MANUAL IDENTIFICATION

Model Number: 64500S
 Date Printed: October 1982
 Part Number: 64500-90910

SERVICE MANUAL CHANGES

Model Number: 64500S
 Date Printed: October 1982
 Part Number: 64500-90910

Page 4-5,

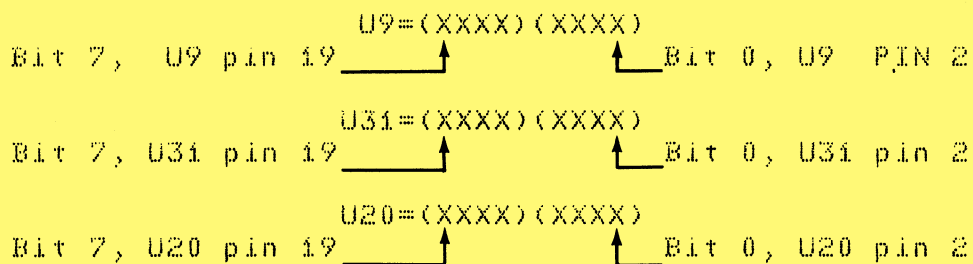
Change: Add ARROWS as shown;

Page 8-2, Figure 8-1, Block Diagram,

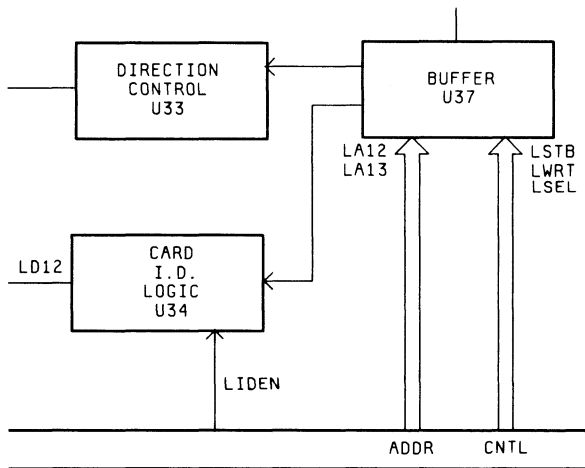
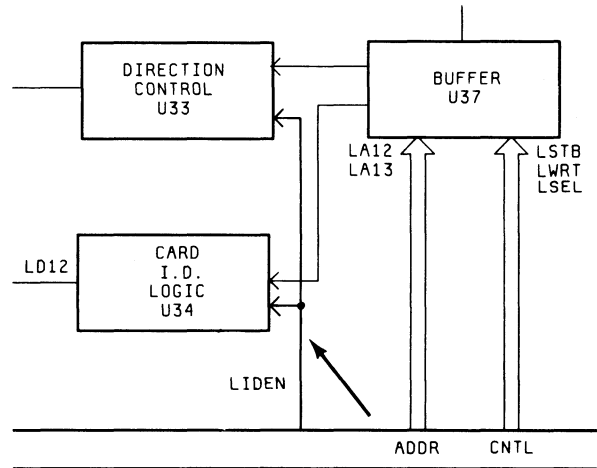
Change: Make changes as shown below to the Block Diagram.
